CCK-2564.0-7-24 Construct Health Education Building BP-01E ADDENDUM #1 02/02/2024

# UK Construct Health Education Building ADDENDUM No. 1 UK-2564.0-7-24 2/02/2023

ADDENDUM NO. 1.00 2/24

Michael D Rankin MD Health Education Building UK Project No. 2564.0-5-24 BP-01E Dimock Sanitary JRA Project No. 202170 University of Kentucky Lexington, Kentucky

Model: ADB-200

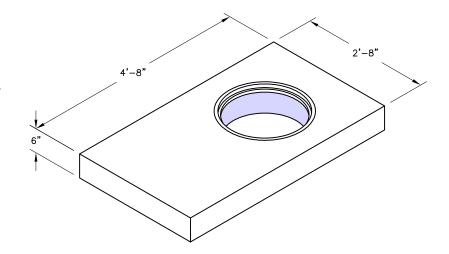
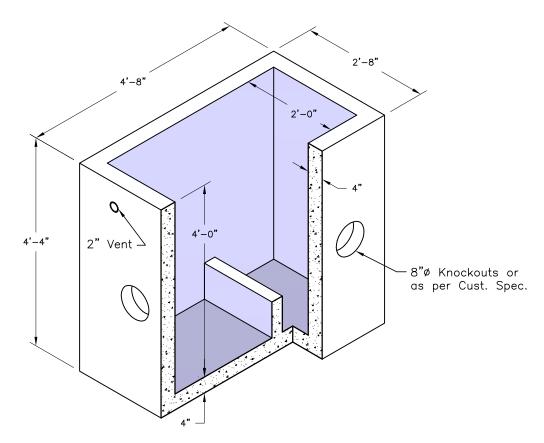
The submitted model or equivalent Acid Waste Dilution Pit would be accepted, provided the invert elevations can be coordinated with the site conditions. (see product information)

Will the attached be acceptable for Acid Waste Dilution Pit. Provided Cloud Precast Model # may be obsolete.

The submitted model or equivalent would be accepted provided the invert elevations can be coordinated with the site conditions.
